**ACE Paper 24/2008**

## **Report on the 104<sup>th</sup> Environmental Impact Assessment Subcommittee Meeting**

**Environmental Assessment Report**  
**Pilot Project for Public-private Partnership Conservation Scheme**  
**at Sha Lo Tung Valley, Tai Po**

**Supplementary information provided by the Project Proponent on Questions raised by  
ACE EIA Subcommittee after the Subcommittee meeting on 8 September 2008**

**Figure 1 Location of Weather Station**

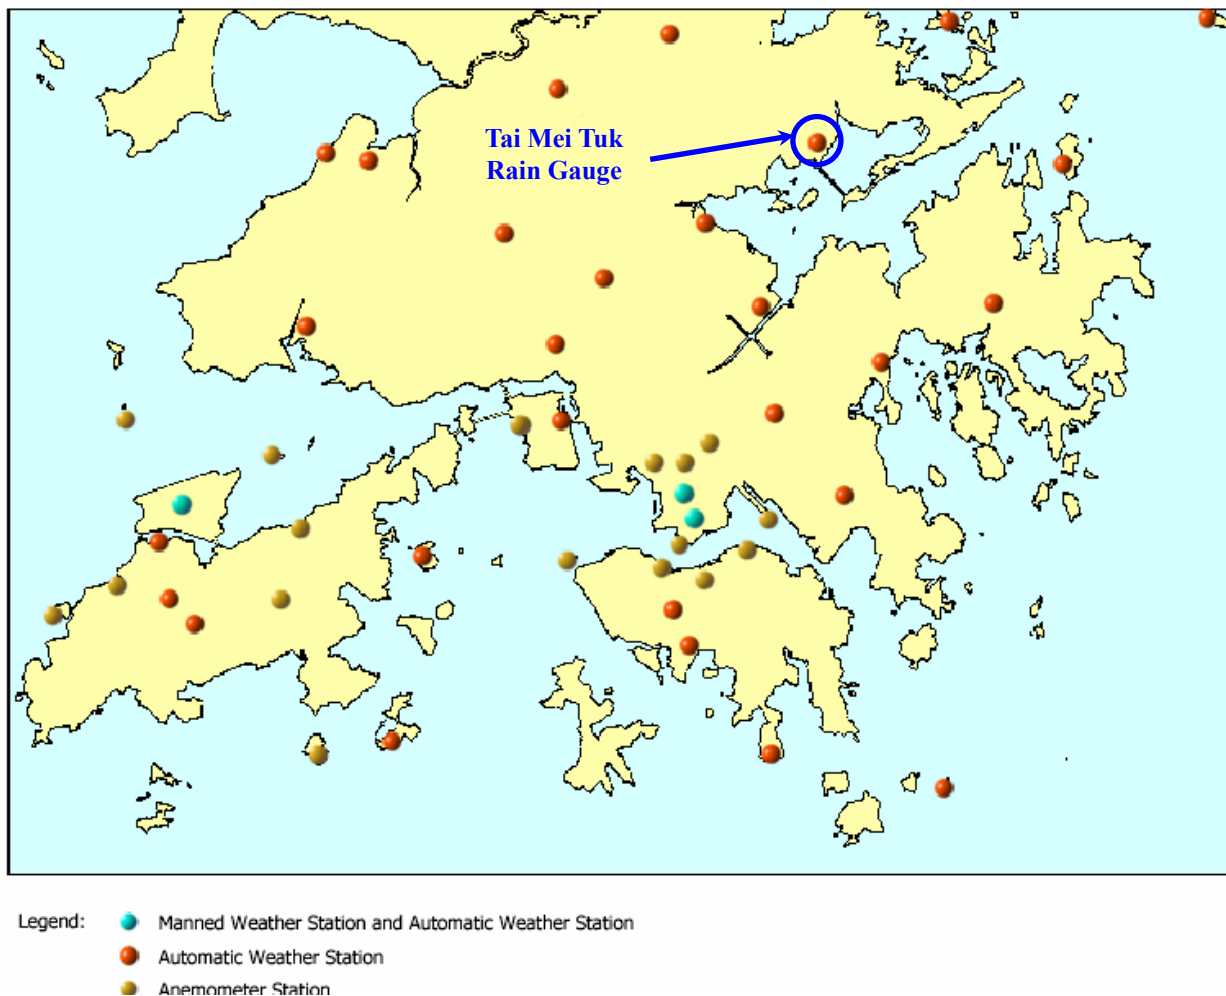
- (a) the estimated extent of reduction in the flow of the local tributary caused by the development on the localized catchment area (i.e. catchment area at and near the development site and not the whole catchment area of the Sha Lo Tung Valley), in particular in dry seasons; and**
- (b) assessment conducted on the localized potential impacts, including the potential impacts on aquatic organisms in the local tributary of the area.**

The streamflow generated within the Sha Lo Tung Valley is referenced from the rainfall data recorded by Hong Kong Observatory’s rain gauge located at Tai Mei Tuk, which is the nearest rain gauge to the Site and is the only rain gauge in the Tai Po area (**Figure 1**). Eight consecutive years of rainfall records were obtained as shown in **Appendix 1**. It was found that the average daily rainfall during the dry season ranges from 2.9mm to 8.2mm (**Table 1**). Over 80% of the days in the dry season had no rainfall. Due to the limited rainfall during the dry season, it is expected that rainfall will mainly percolate through soil rather than flow over the land surface entering Sha Lo Tung Stream within the catchment area.

Figure 2 Sub-Catchment Areas within Basin 11 (Not to Scale)

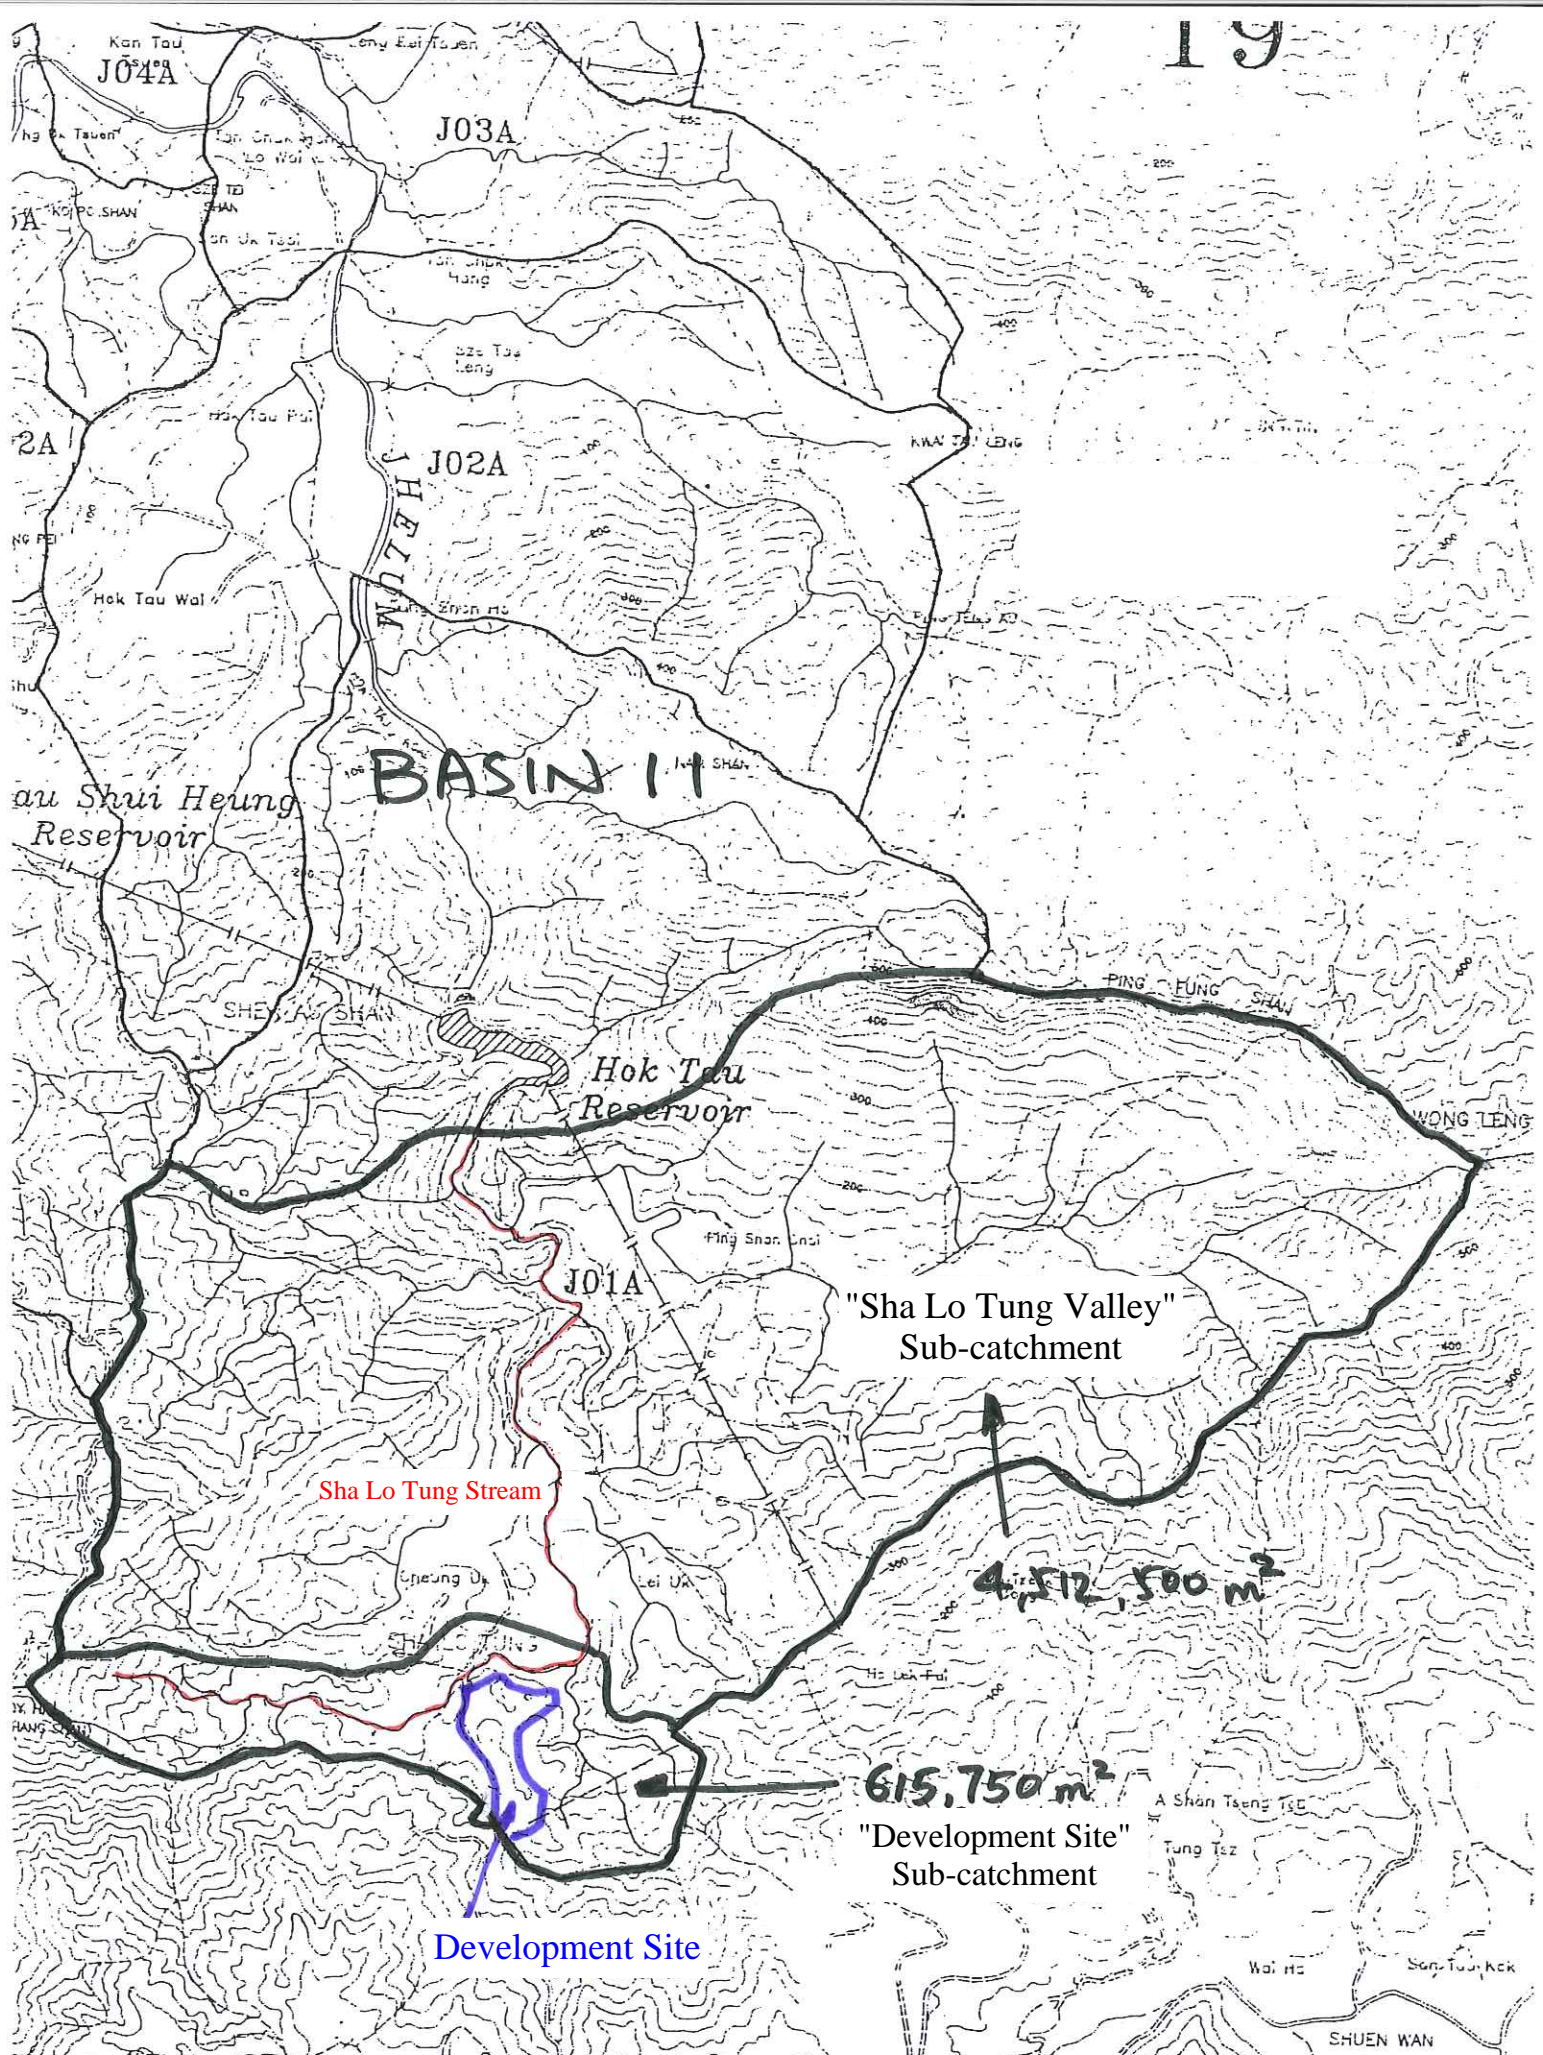
**(1) Regarding the Sha Lo Tung Stream which is located to the north of the proposed development site (Fig 5.3 of the EA report refers), Members were concerned about the impacts arising from the loss of catchment area on the streamflow and aquatic ecology caused by the development. Please provide information on –**

Sha Lo Tung Stream falls within “Development Site” Sub-catchment and “Sha Lo Tung Valley” Sub-catchment of Basin 11, with total areas of approximately 615,750m<sup>2</sup> (= 61.575 ha) and

4,512,500m<sup>2</sup> (= 451.25 ha) respectively (**Figure 2**). The Development Site is a rural knoll area, originally with a small farming area located at the northern part of the area and some graveyards located at the uphill areas within the site. There are no watercourses/ tributaries passing through the Development Site or the areas (which identified as woodland habitat) between Sha Lo Tung Stream and the Development Site. Any paved areas within the Development Site have the potential to restrict the dry season rainfall percolation. The paved areas within the Development Site during construction and operation is expected to be approximately 1.69 ha and 1.46 ha respectively (refer to *Table 4.13* of the EA Report).

The estimated extent (%) of reduction in the dry season streamflow of the southern section of Sha Lo Tung Stream (immediate adjacent to the Development Site) caused by the development on the localized catchment area (“Development Site” Sub-catchment) during construction and operation of the Development Site is expected to be approximately 2.74% (=1.69 ha/ 61.575 ha x100) and 2.37% (=1.46 ha/ 61.575 ha x100) respectively. The estimated extent of reduction in the dry season streamflow of the whole Sha Lo Tung Stream (including both “Development Site” and “Sha Lo Tung Valley” Sub-catchments) caused by the development during construction and operation of the Development Site is expected to be approximately 0.33% (=1.69 ha/ (61.575+451.25 ha) x100) and 0.28% (=1.46 ha/ (61.575+451.25 ha) x100) respectively.
